Groundwater Transfer Review Summary Form

Transfer/PA # T- 13654

Application: T-13654

Applicant Name: Castle Rock Farming, LLC

Water-Level Trend in Nearby Wells

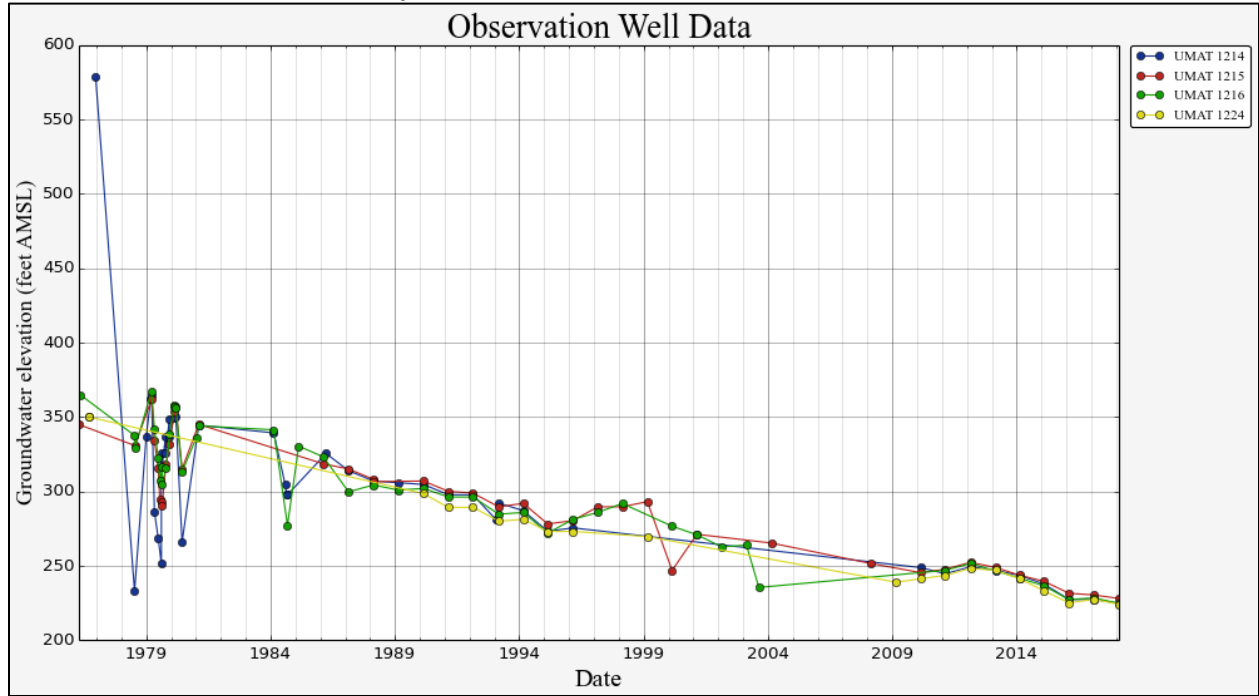
2. Will the proposed POA develop the same aquifer (source) as the existing authorized POA?
 Yes No Comments: All subject wells produce water from water-bearing zones in the Columbia River Basalt Group aquifer system. As shown below in the Well Location Map, the five wells are located in the same subarea (A) of the Stage Gulch Critical Groundwater Area, which is managed as a single source. The subject wells have similar water-level elevations and trends (see below).
